STATE OF NORTH CAROLINA
DEPARTMENT OF TRANSPORTATION

Subject: **Modification Request for Section 404 Individual Permit, Section 401 Water Quality Certification and Neuse Riparian Buffer Authorization** for Interstate 40 Widening and Improvements from I-440/US 64 (Exit 301) to just north of SR 1525 (Cornwallis Road), including improvements to NC 42 and SR 1010 (Cleveland Road) in Wake and Johnston Counties, Federal Aid Project No. IMNHF-040-4(139)301; TIP Numbers I-5111 and I-4739, Divisions 4 & 5; Debit \$570 from WBS Element 42346.3.1.

It has come to our attention that several wetland and riparian buffer impact areas require revisions. The buffer areas were visited in the field by staff from NCDOT, RK&K, and S.T. Wooten on December 2, 2019. These issues have been brought to your and Mr. Rob Riding's attention by Division 5 staff. Attached are revised permit drawings depicting the affected areas, all of which have a revision date of 12/12/2019.

LOCATION: I-40 FROM I-440 /US 64 (EXIT 301) TO JUST NORTH OF SR 1525 (CORNWALLIS ROAD), INCLUDING IMPROVEMENTS TO NC 42 AND SR 1010 (CLEVELAND ROAD).

PERMIT DRAWING SHEET 84 OF 125

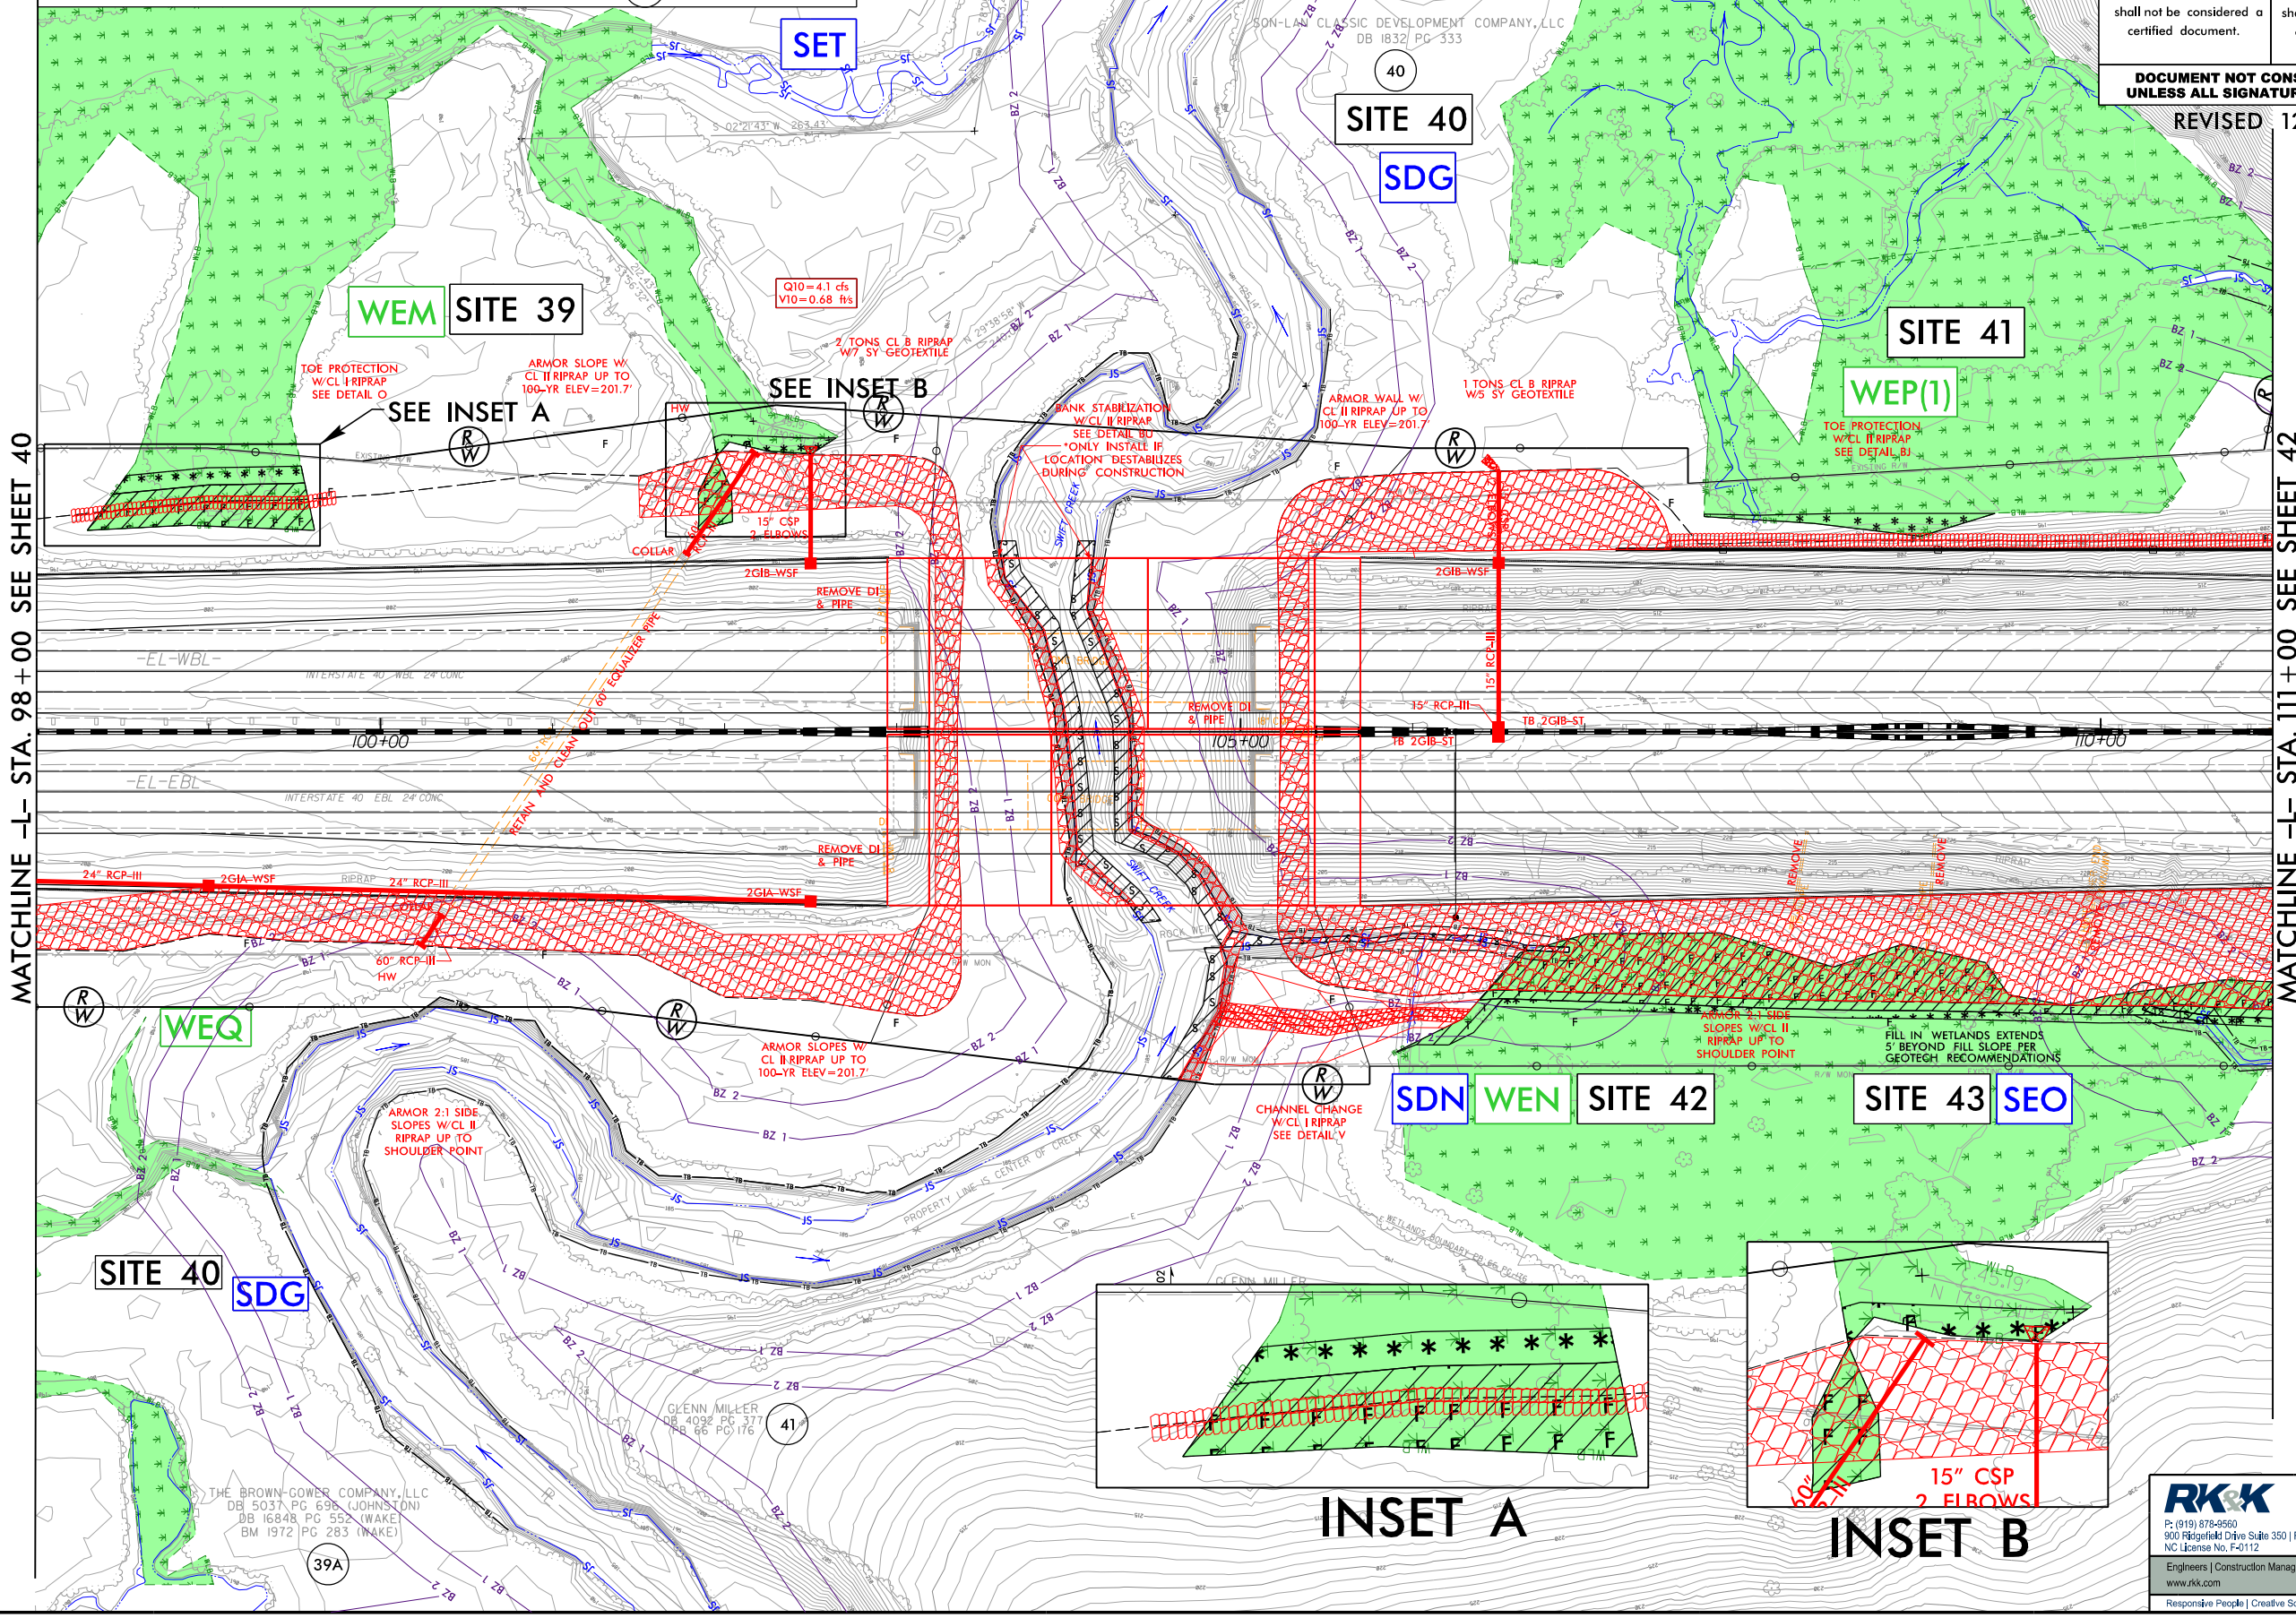
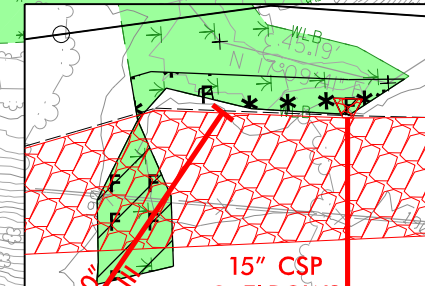
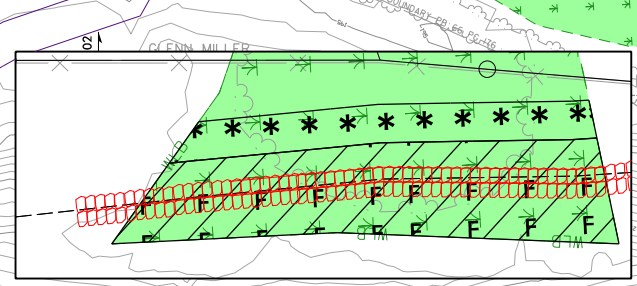
3. Site 42, -L- 106+38 – 111+14 RT will change a portion of the mechanized clearing to permanent fill in wetland. This is due to a Geotech recommendation to push riprap into the soft soils 12” – 24” deep in the area of the wetland. This limits the amount of undercutting that will need to occur. The Geotech recommendation states the station range is appr. -L- 110+00 – 125+00. The actual impacts due to the wetland shape are in the station range -L- 106+38 – 111+14. (There is a portion of temporary fill in wetland that will change to permanent fill in wetland, 0.002 ac, but it is so small that it is lost due to rounding). We do not anticipate a draining effect on the wetlands. The relocated channel will serve to function like the stream we are removing (SDN). There will be no voids in the riprap that is installed therefore we do not anticipate a discharge. Soil will be prevalent throughout the riprap.

- Site 40: previous permanent stream impact: 254', temporary stream impact: 90'; new permanent stream impact: 334', temporary stream impact: 10'

stream impact as bank stabilization. Previously it was considered temporary impact under construction and dewatering activities.

PERMIT DRAWING
SHEET 91 OF 125

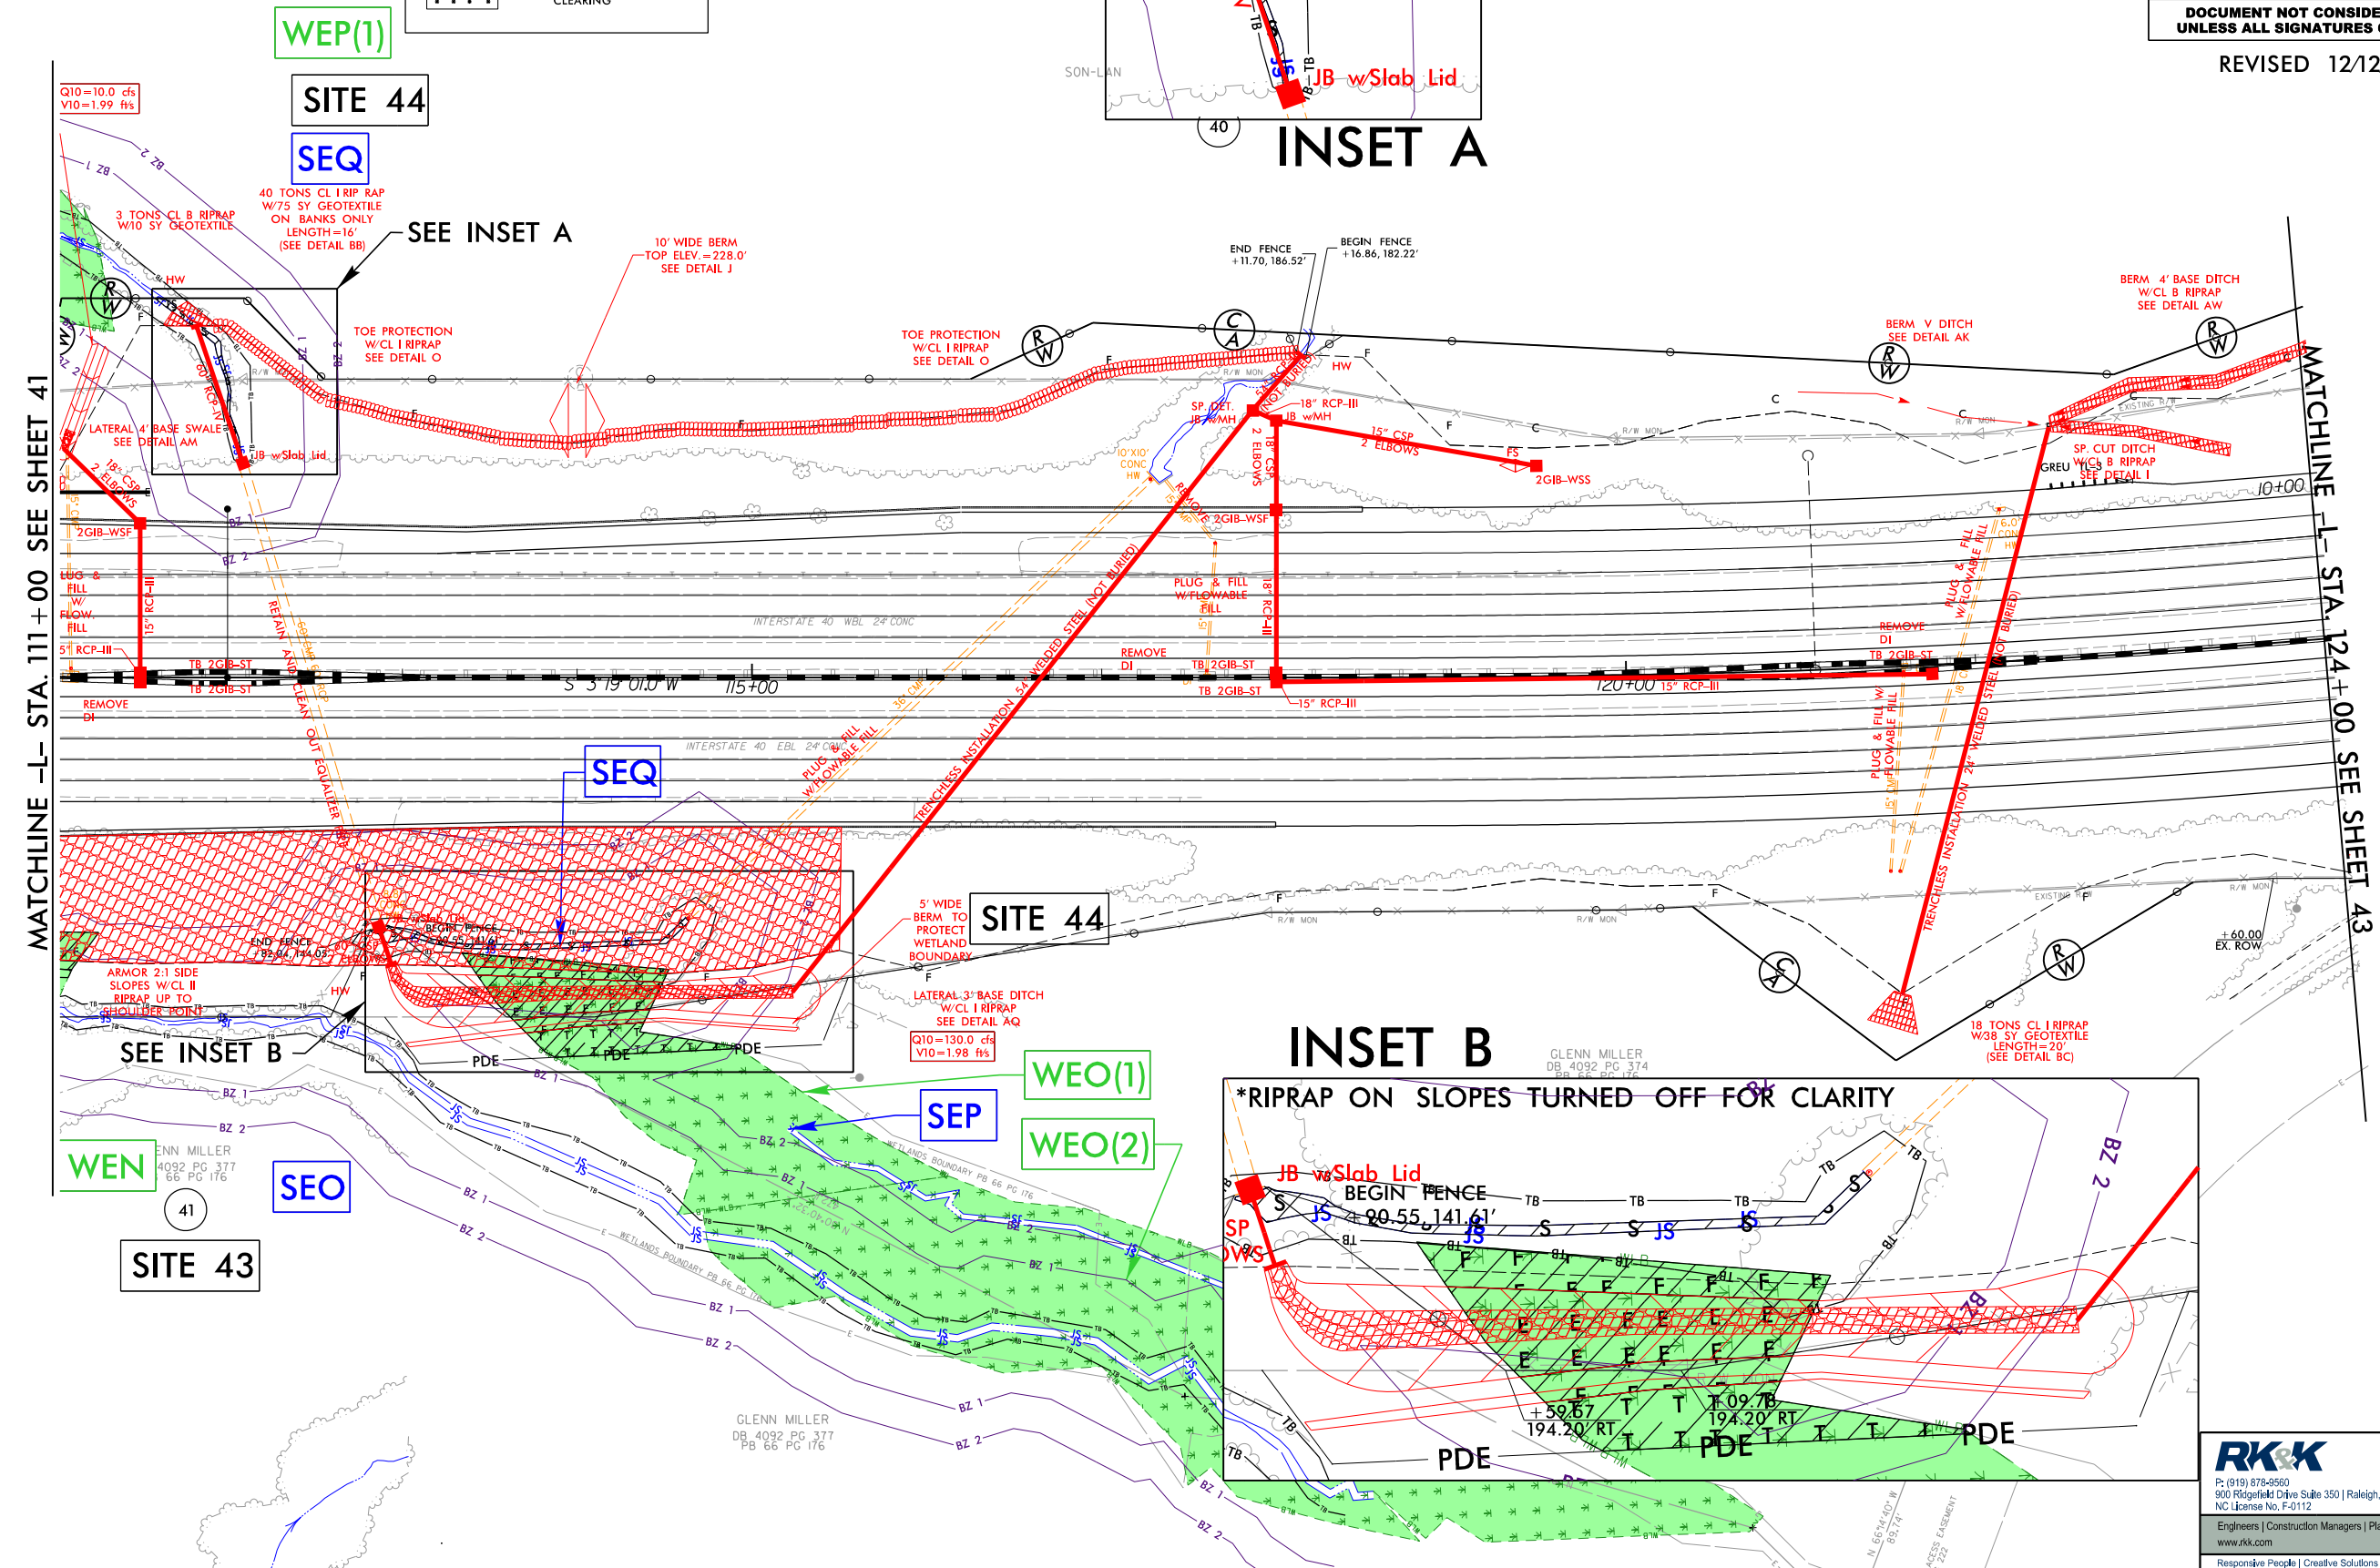
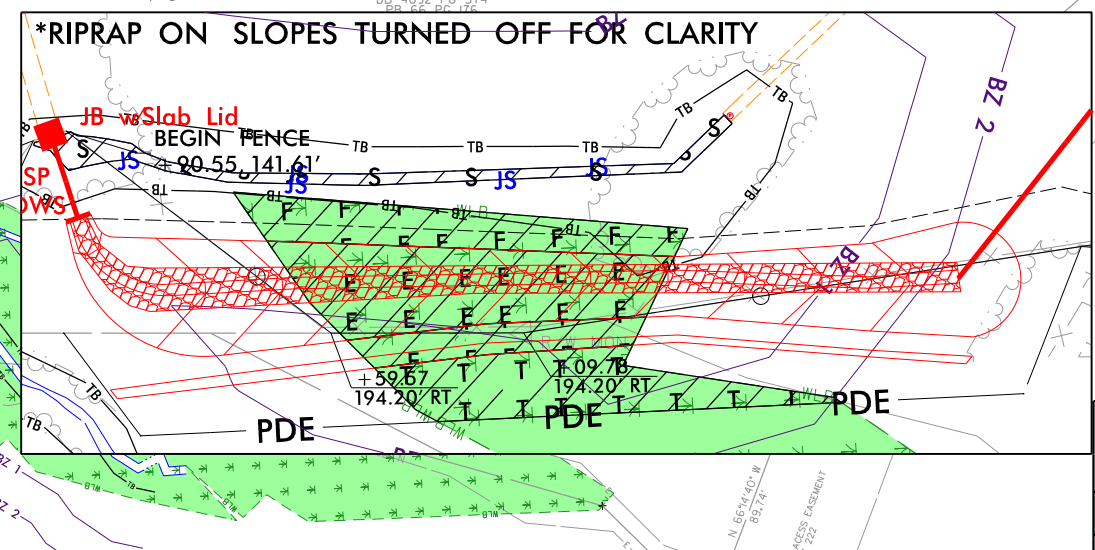
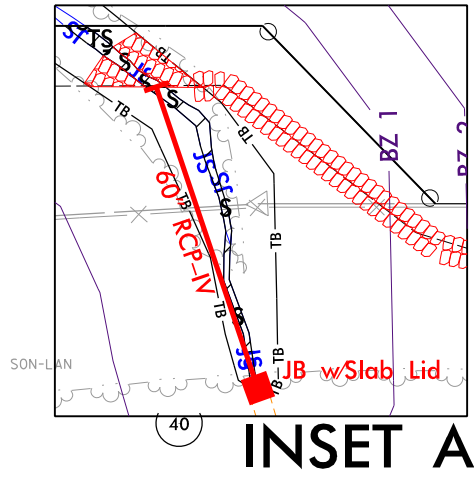
4. There is a tributary at STA 110+00 -L- Rt which is within the foot print of the proposed Geotech recommended changes. The contractor is not proposing riprap within the stream channel; if during construction it is determined that riprap is required for long term stability, it will be installed deep below the exiting channel with enough backfill over it to retain the silt bottom of the channel. For this reason, the temporary impacts to the channel remain the same.

- Permit drawing 91 of 125: plansheet 42 reflecting revisions to Site 42
- Permit drawing 92 of 125: plansheet 42 reflecting revisions to Site 42
- Site 42: previous permanent fill in wetland: 0.23ac, previous mechanized clearing: 0.10 ac; new permanent fill in wetland: 0.29 ac, new mechanized clearing: 0.05 ac (note that rounding with all project impacts makes the total project increase in permanent fill in wetland 0.05 ac and the decrease in mechanized clearing 0.05 ac).
